HISTORIC AND DESIGN REVIEW COMMISSION

HDRC CASE NO: 2020-246

ADDRESS: 1024 DAWSON ST

TYPE OF WORK: Construction of a 2-story, rear accessory structure

EXISTING HOME + NEW APARTMENTS

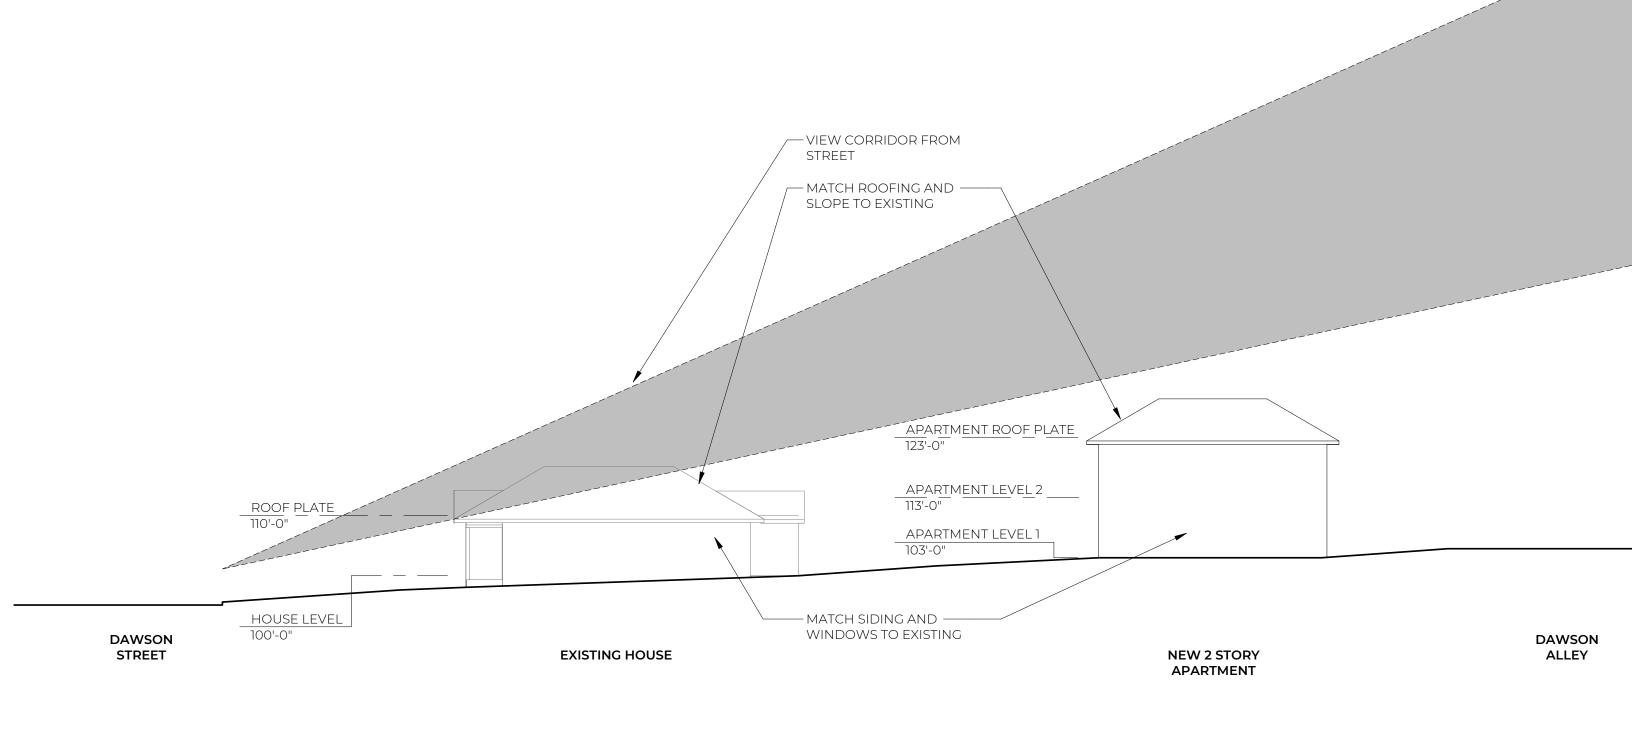
- footprint is appropriate and that the building footprints would not exceed fifty (50) percent of the buildable lot coverage.
- c. MASSING & FORM Regarding the overall height, the applicant has submitted a line of sight study that notes that the proposed two story structure would not be visible from the right of way due to its distance from the right of way at Dawson. Generally, staff finds that the applicant should explore ways to reduce the overall height of the proposed accessory, such as through reduced floor heights.

- i. That the applicant explore ways to reduce the overall height of the proposed rear structure.
- ii. That in developing construction documents for final approval, the applicant match the materials of the primary historic structure.
